Re: Issued for Construction
Letter of Recommendations
South Slope of West Pond
Scrubber Sludge Complex
Paradise Fossil Plant
Paradise, Muhlenberg County, Kentucky

Subject: Review of Stantec Letter of Recommendations, South Slope of West Pond, Geotechnical Exploration, Scrubber Sludge Complex, Paradise Fossil Plant, Paradise, Muhlenberg County, Kentucky AECOM Project No. 60140251, Task 200.1

Figure 3. Cross Section A-A' without under-drains

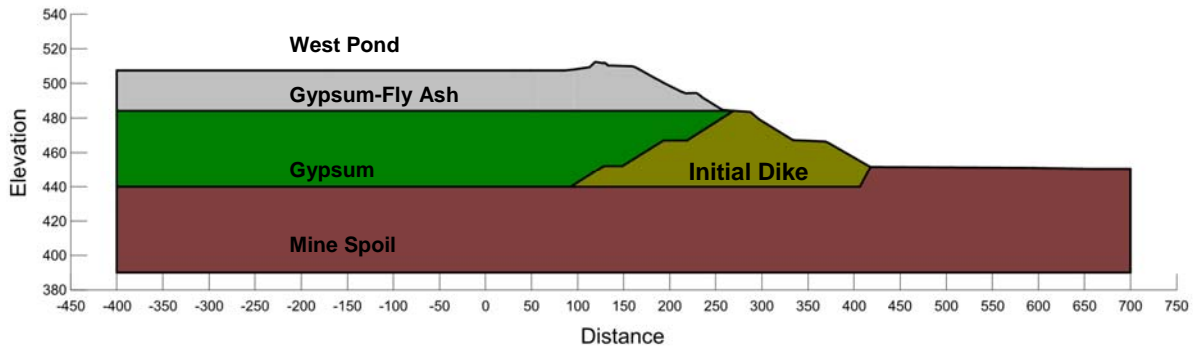
- The report does not contain a geological cross-section of Section A-A' which was likely needed for analysis. This figure would be useful depicting piezometer locations, observed water levels and the dike slope seepage outbreak or wet surface areas.
